**Before the Hearings Panel
At Waimakariri District Council**

In the matter of the Proposed Waimakariri District Plan (PDP)

**Council Reply Report on Hearing
Stream 12A Rezoning Requests – Whitua
motuhaka Special Purpose Zone – Pegasus
Resort (SPZ(PR)) on behalf of Waimakariri District Council**

Date: 5 September 2024

Figure 1: Landscaping shown along the boundary with the Main North Road

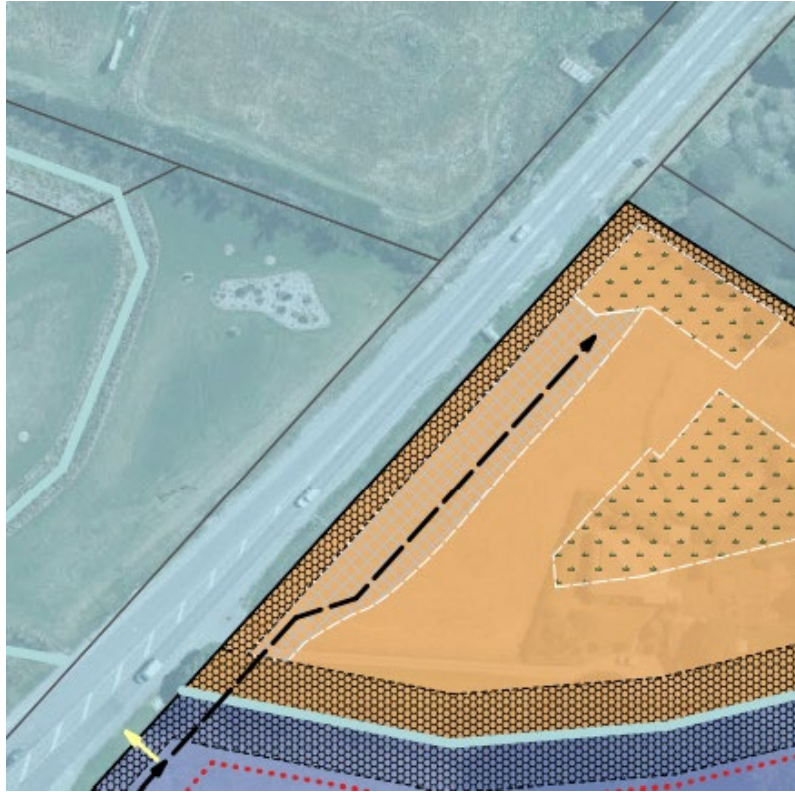
146 In evidence, DEXIN proposed to relocate the majority of the residential areas into the northern corner of the site, and Ms Pearson considers the non-habitable garages and landscape buffer (refer to **Figure 1** below) would provide mitigation. I note that the revised ODP, attached as Appendix 3, now shows a landscaped car access and parking along the boundary to Main North Road, which provides certainty that this would be provided.

147 In my view, the Residential activity rule (SPZ(PR)-R2) should enable consideration of amenity effects from Main North Road and the proposed Woodend Bypass on residential activities. I consider this can easily be provided with a link to matter of control SPZ-PR-MCD4 which relates to amenity values. Including SPZ(PR)-MCD4 as a matter of control in SPZ(PR)-R2 has been agreed in the Planning JWS.

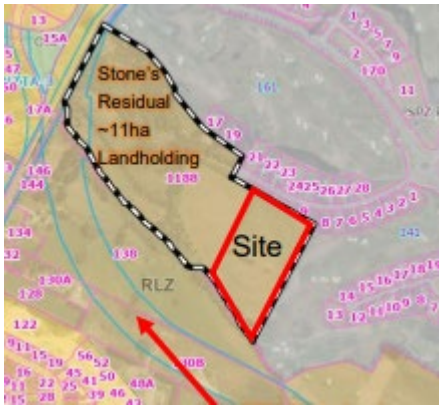
Amend the map to rezone the part of 1188 Main North Road (20 Te Haunui Lane), as outlined in red below, as SPZ(PR).¹⁴¹

Appendix 3: Proposed amended SPZ(PR) Outline Development Plan with DEXIN site included

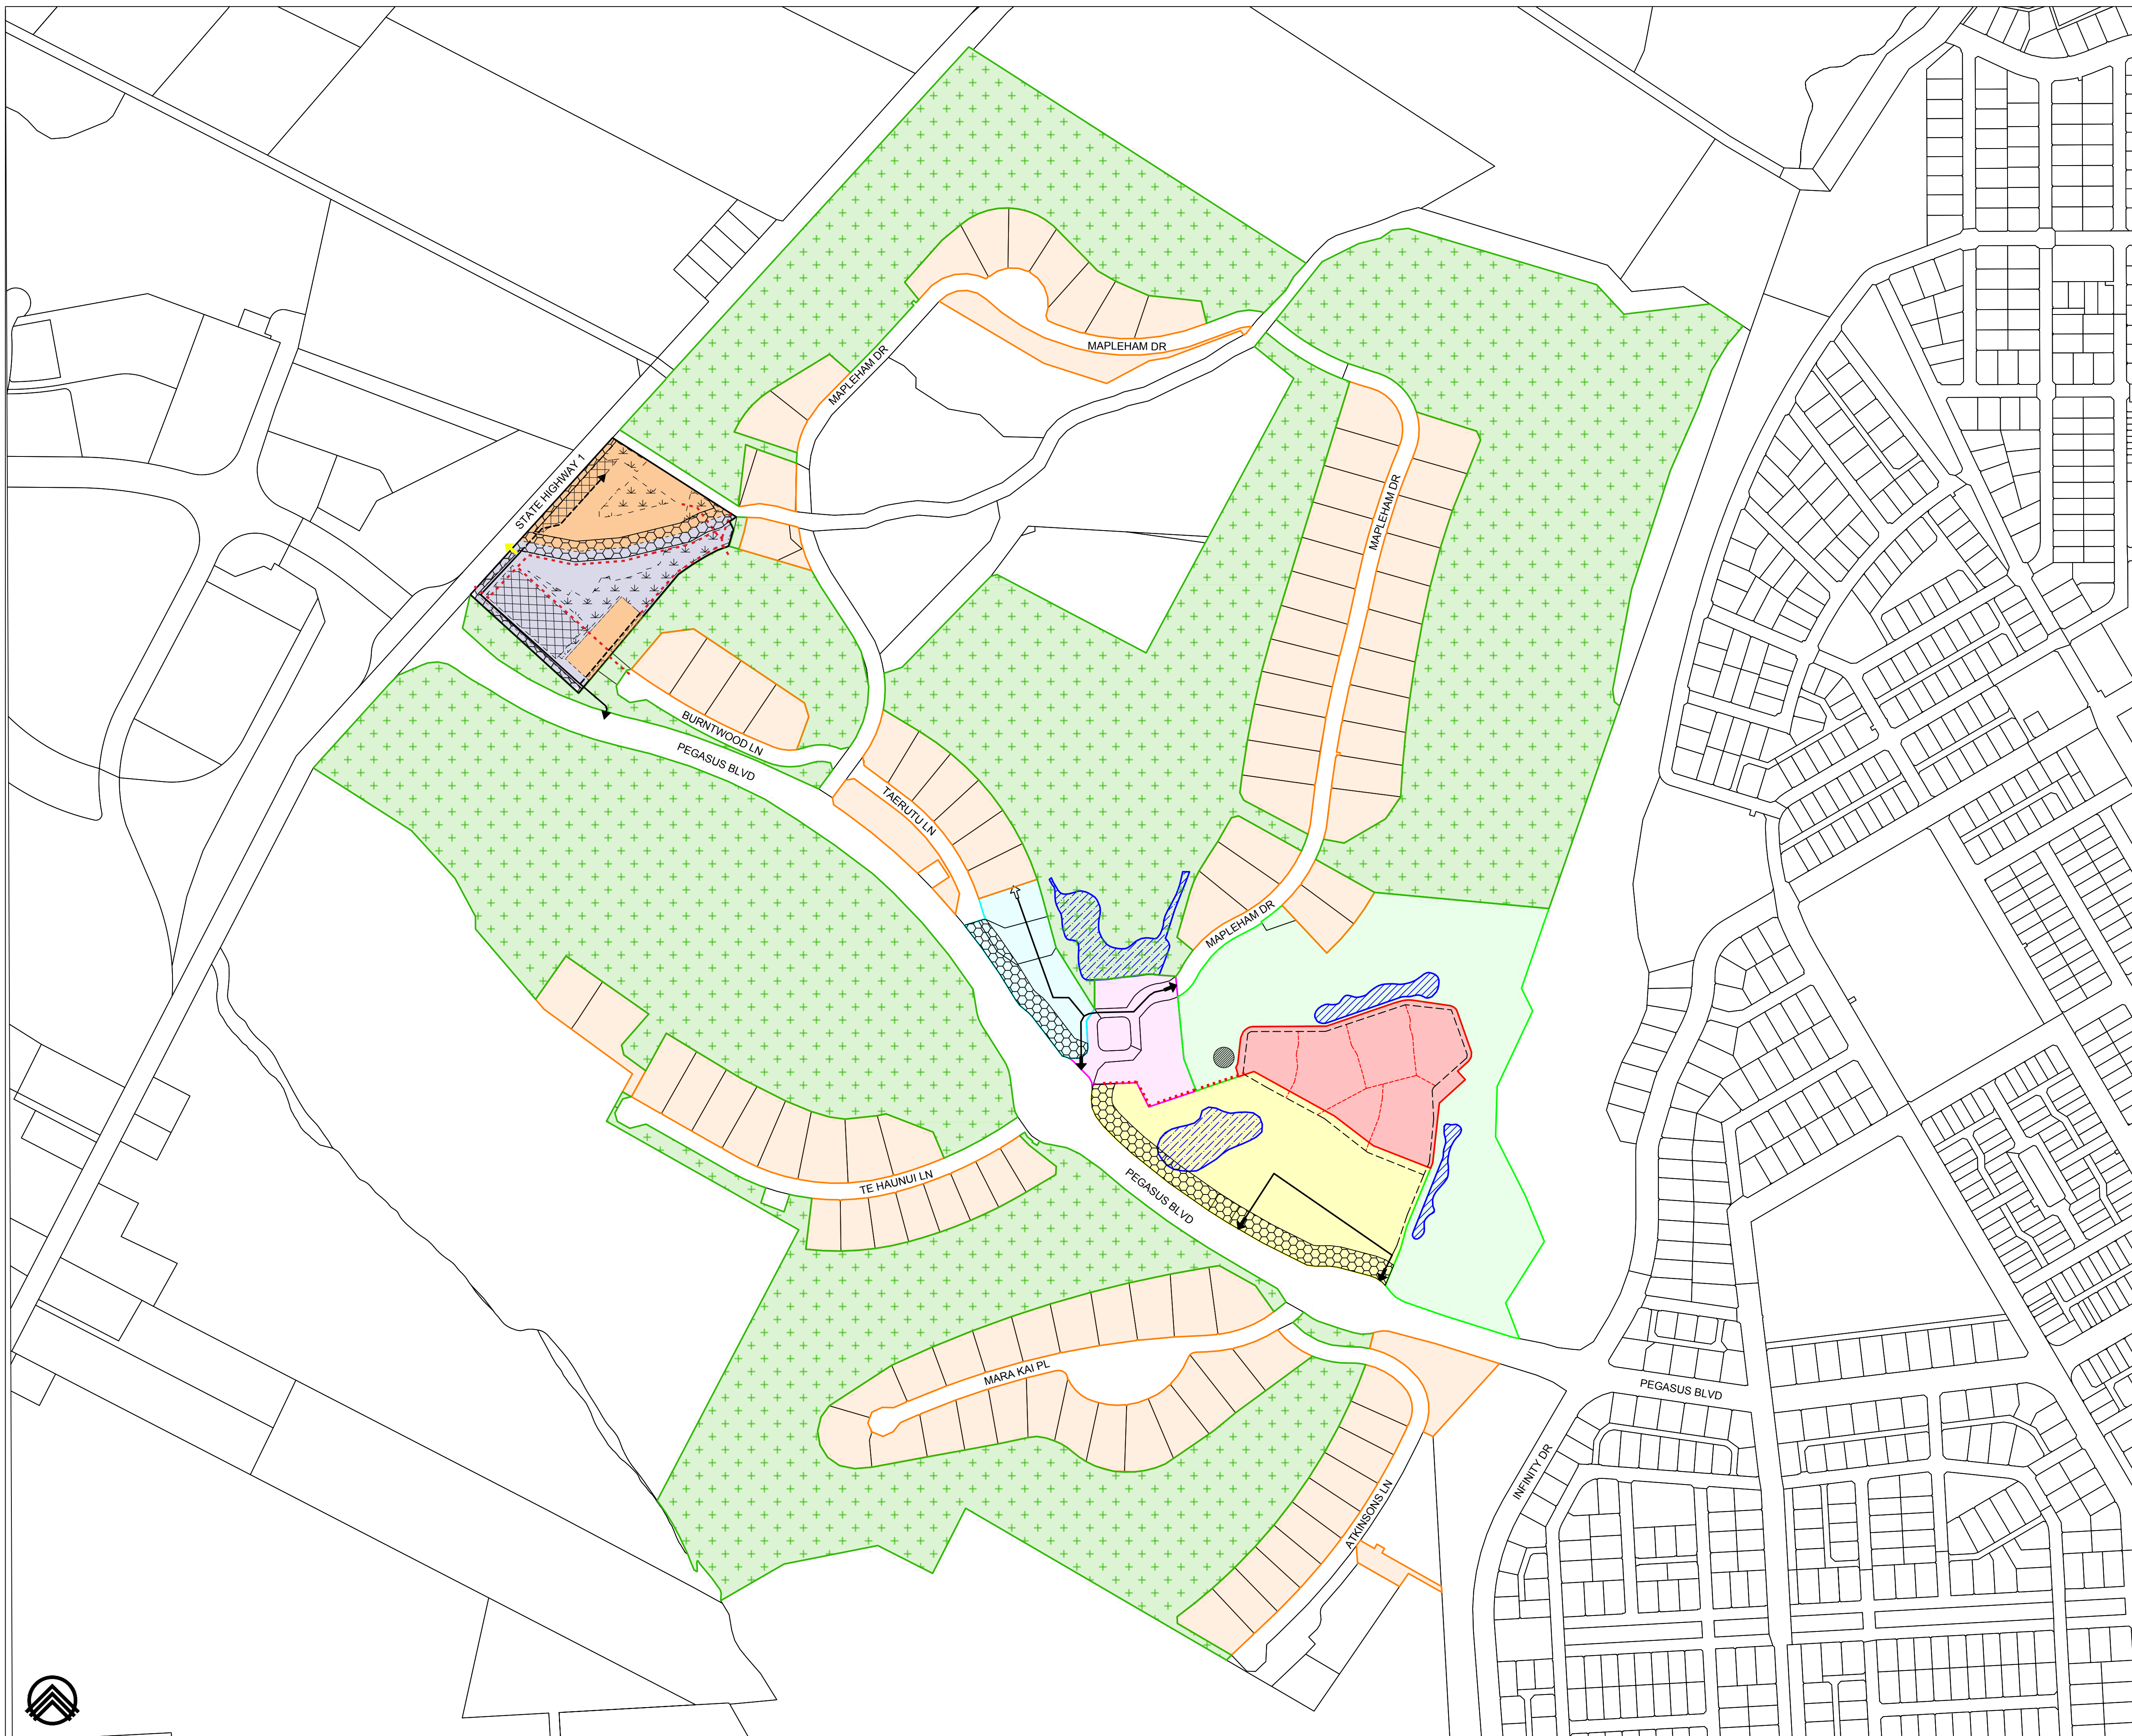
145 Mr Lunday has provided a summary of the changes to the ODP in pages 13 and 14 of his evidence. Mr Lunday and Mr Jolly have undertaken expert conferencing and have agreed on an amended ODP provided in Appendix A of the Urban Design JWS and has been attached as Appendix 3 to this Reply Report.
